Subject: Crescent at Central Park Section 2- Lot 2
City of Gahanna, Franklin County, Ohio
CEC Project 314-902

CEC received comments from the City of Gahanna dated 5-18-2022. Please see our responses in Red.

RE: Project Buckles Court North (Lot 2) Design Review/C of A

STAFF REPORT

SITE PLAN

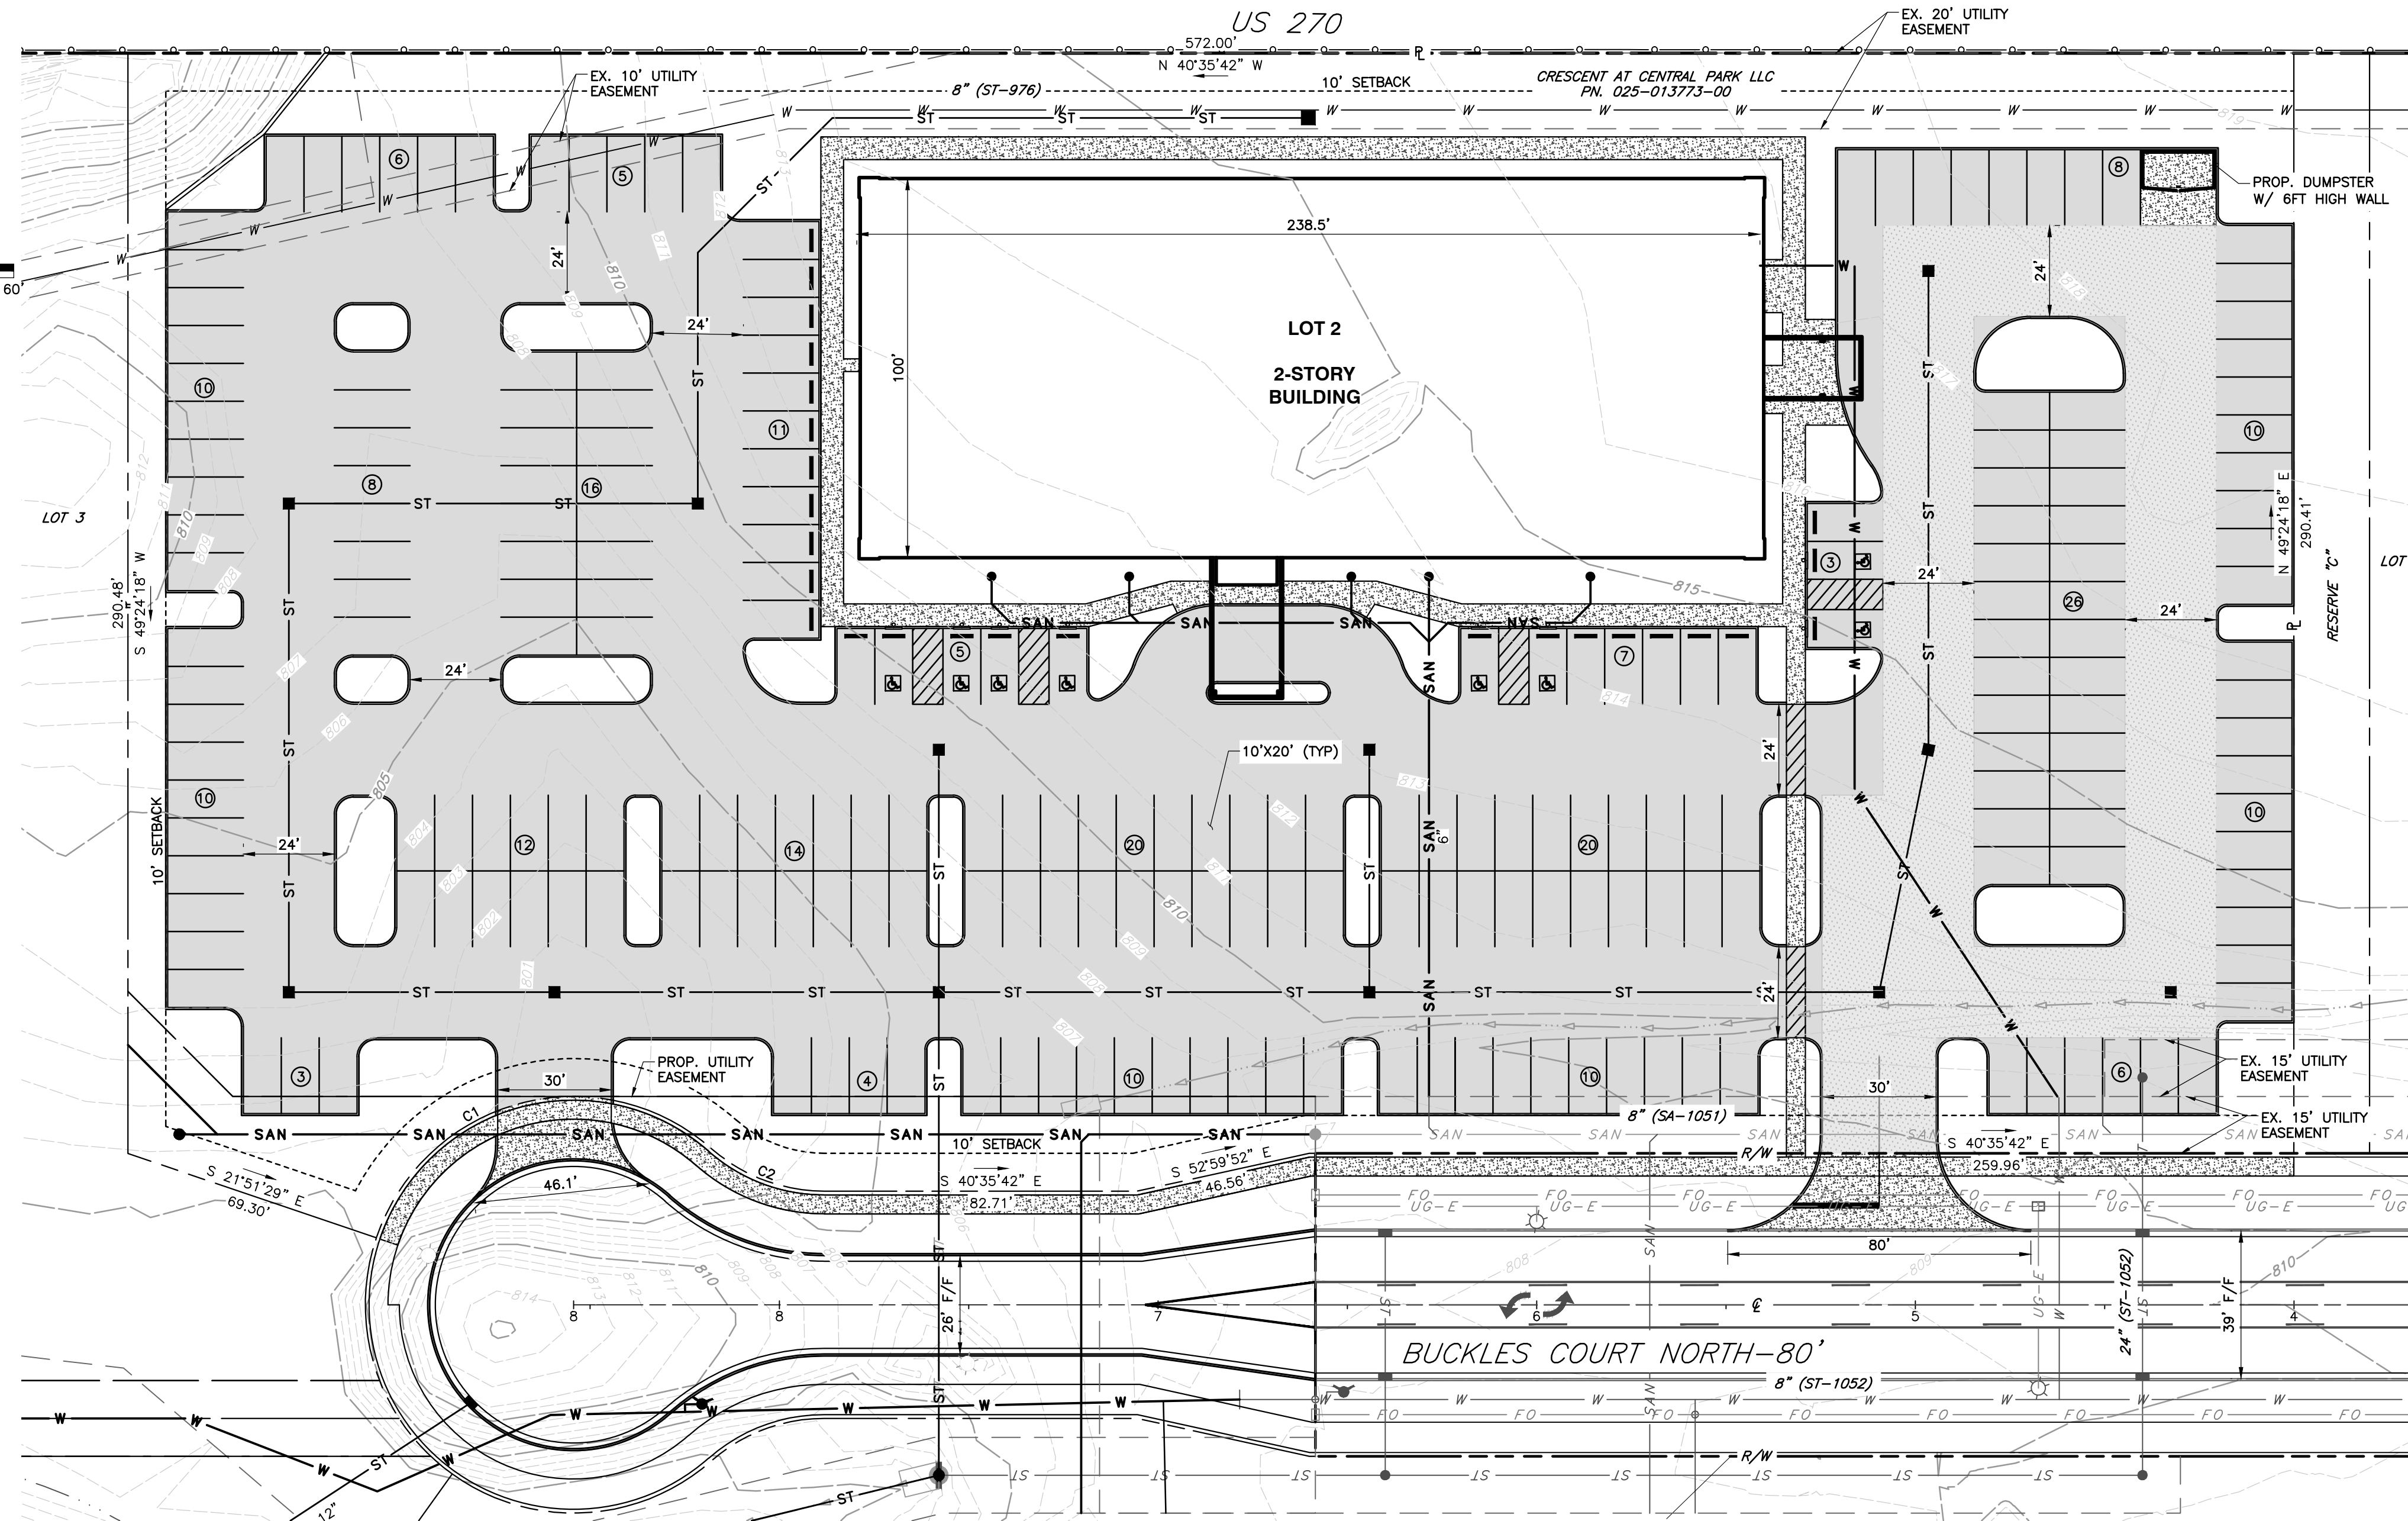
3. Parking for medical uses are based on the number of exam rooms and the amount of staff. Please see CH 1163.02(a) for details and please revise accordingly.
Parking data has been revised based on exam rooms and largest shift.

4. Please revise the site statistics table to include building height. It appears the proposed two story building will meet code requirements, however the height in feet needs to be included.

The building height has been added to the site statistics table.

LANDSCAPE PLAN
SCALE: 1"=30'

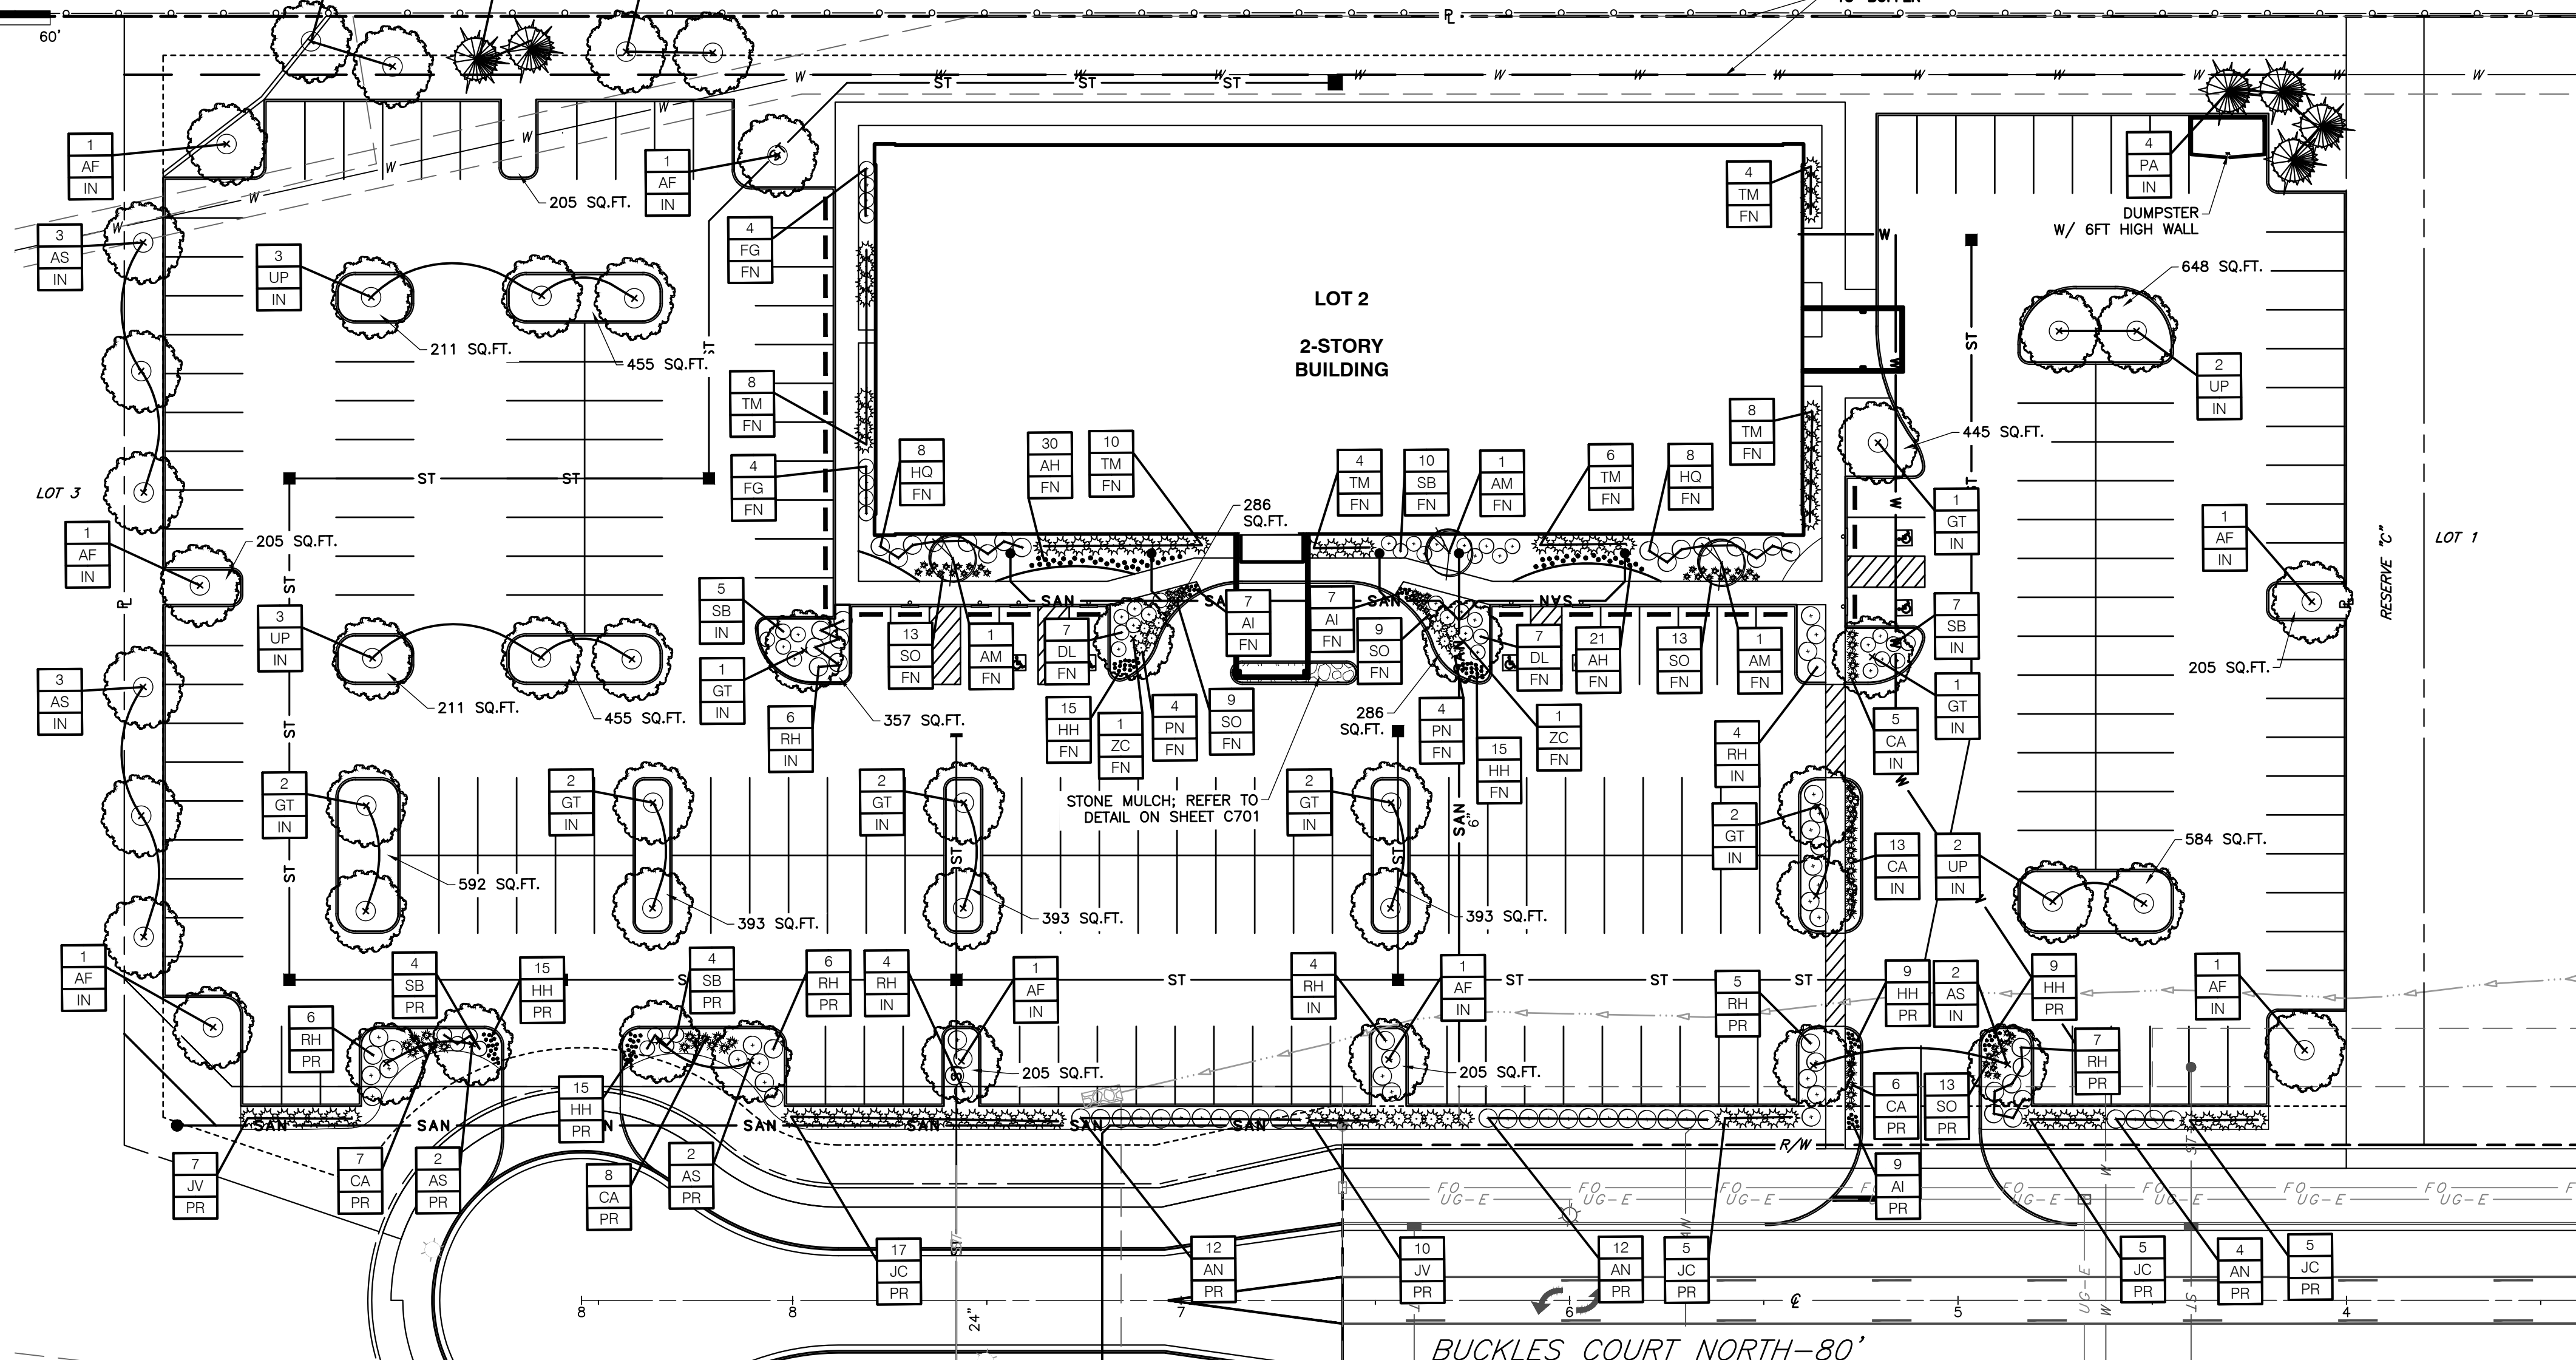
4. It appears that the tree planting requirements of Chapter 1163 have been met but not Chapter 914. Planting requirements of 914 are in addition to those of other chapters (CH 914.02). An additional 75 tree inches need to be planted. Please be aware that the 75 inches are in addition to the planting requirements required in the buffer along the

freeway. Credit is given to any protected trees that are saved. Please revise the landscape plan accordingly.

5. Chapter 1167.20(b)(7) requires a 15' buffer along the property line adjacent to the freeway. One tree every 30' is required and a 6' continuous hedge, fence, wall or mound is required. Please revise the FDP to depict the 15' buffer. The Design Review application should be revised to depict the location of the buffer and screening.

The previously submitted landscape plan does account for section 914. See below:

SHADE TREE CALIPER INCH REQUIRED	129 (128,545 FT ² /1,000 FT ² PER CALIPER INCH) 51.6 TREES (2-1/2" CALIPER)
SHADE TREE CALIPER PROVIDED	130 CALIPER INCHES 52 TREES (2-1/2" CALIPER)

REQUIRED LANDSCAPE AREA:	4,970 SQ. FT (99,395 FT ² * .05)
PROVIDED LANDSCAPE AREA:	6,734 SQ. FT
REQUIRED TREES FOR PARKING AREA	50 ((99,395 FT ² * .05)/100 FT ² PER TREE)
PROVIDED TREES FOR PARKING AREA	50 TREES (3" CALIPER)

Variance request to provide the 15' buffer but with no screening provided.

DETAIL 700 - SHADE TREE PLANTING DETAIL
NOT TO SCALE

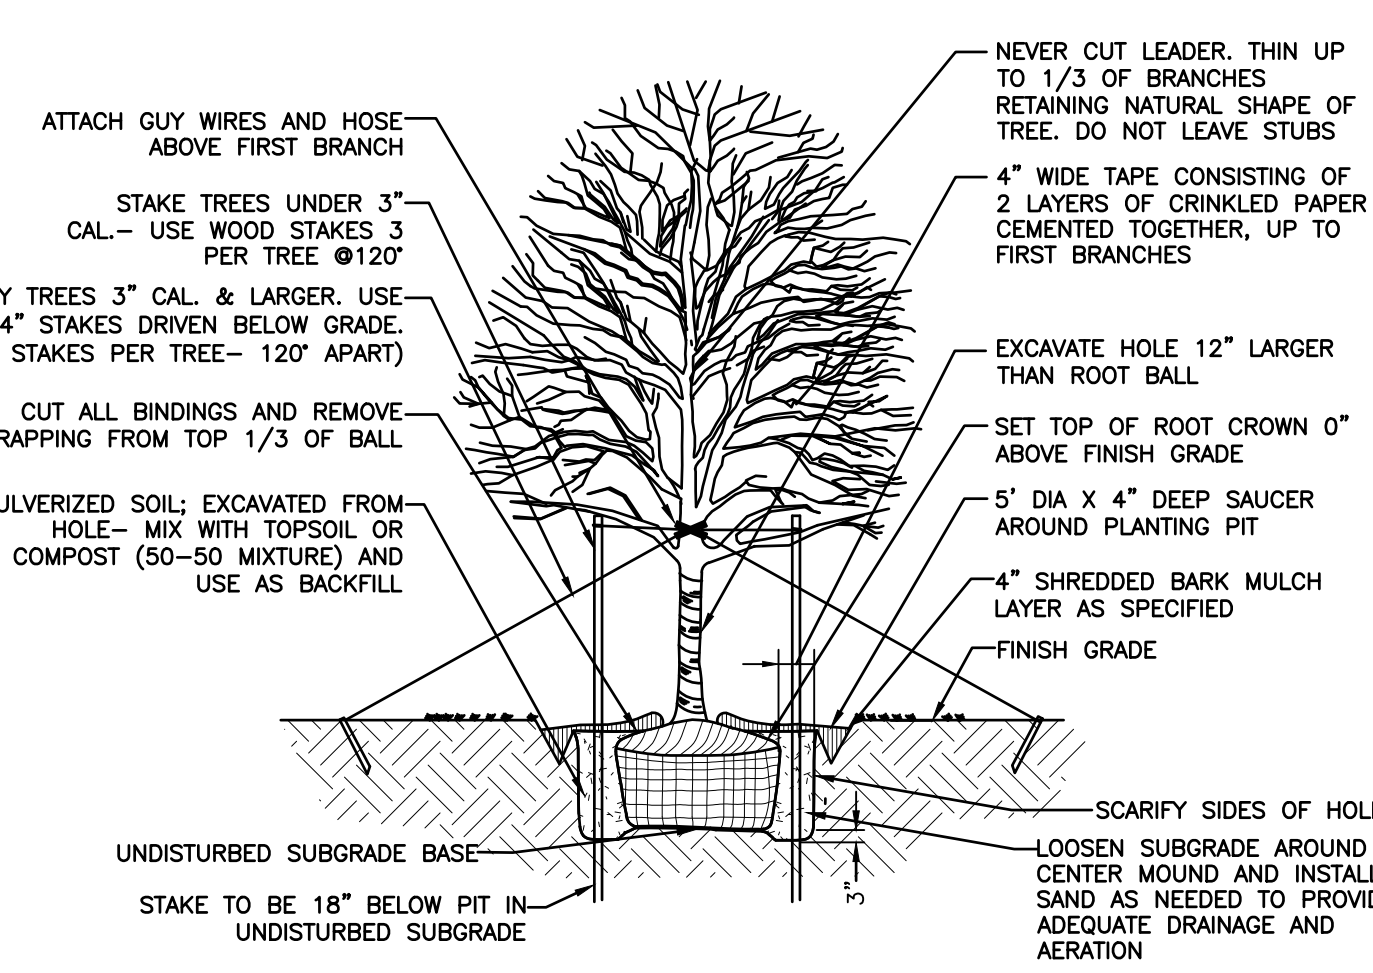
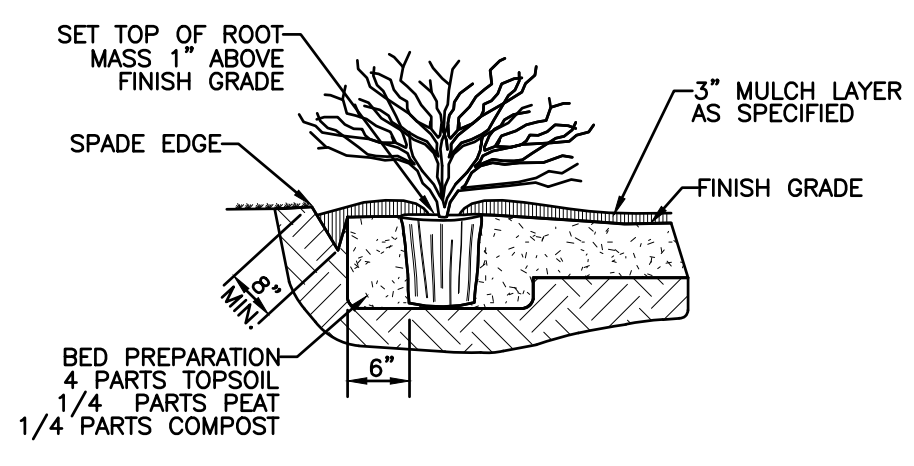
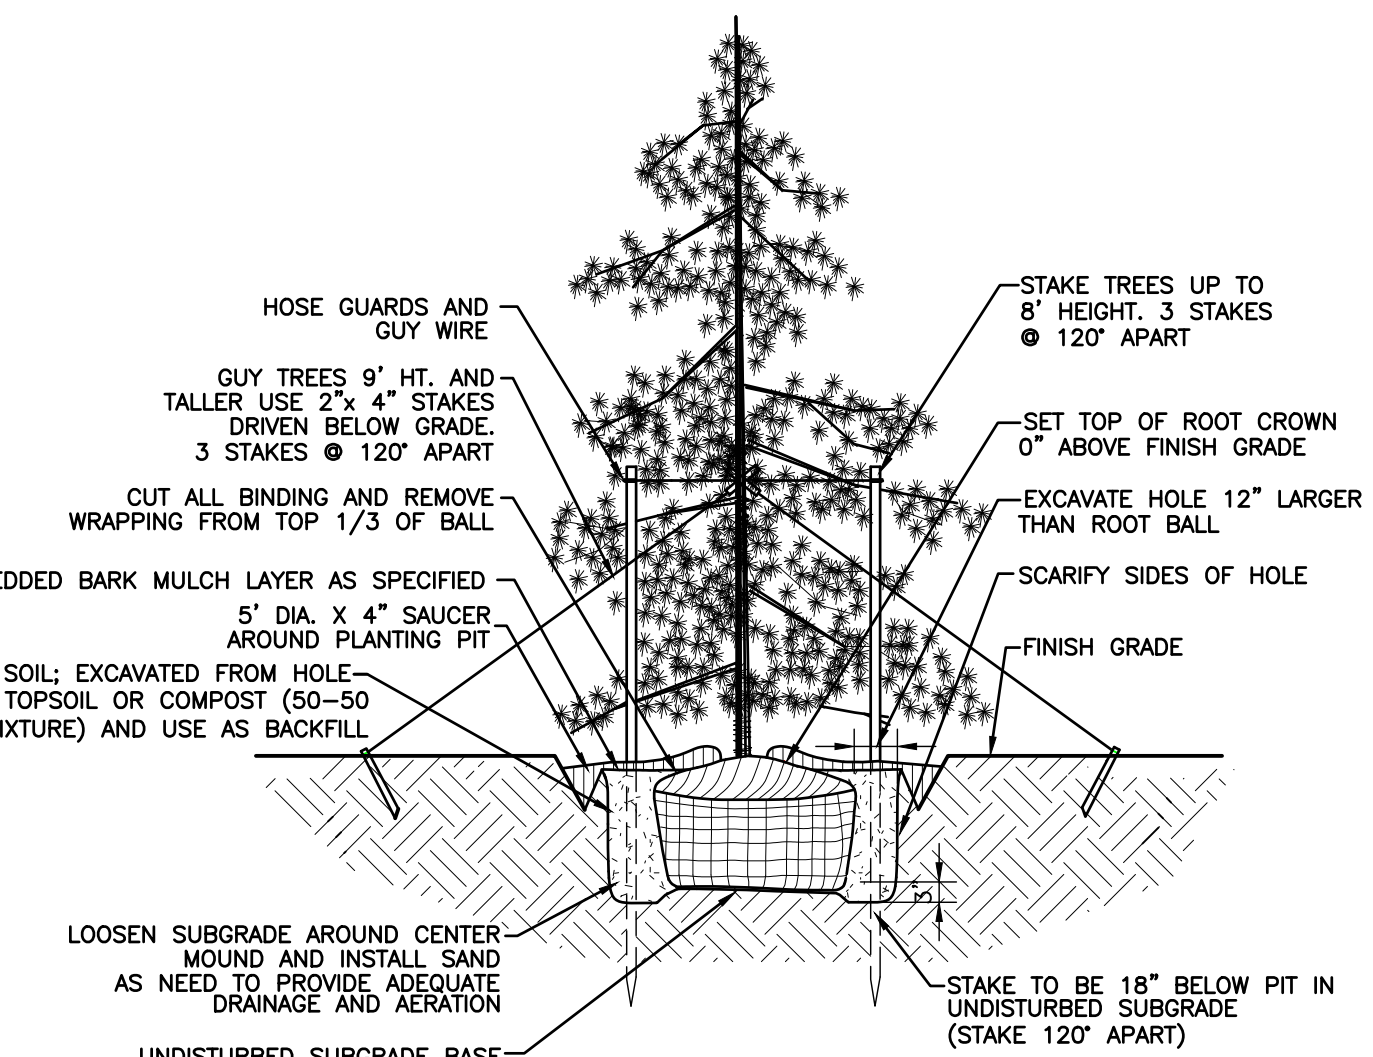
6. Species selection looks acceptable. I was worried about the “bush honeysuckle” at first glance, but I see that it is Diervilla spp. instead of Lonicera spp. It does not look like Diervilla spp. show invasive tendencies at this time. Planting details need to be adjusted to show root flare even with finished grade instead of top of root crown 4”

above finish grade. Mulch should be pulled away from the trunks of trees. Top 1/3 of burlap and metal basket should be removed from the root ball at a minimum.

Planting details have been updated.
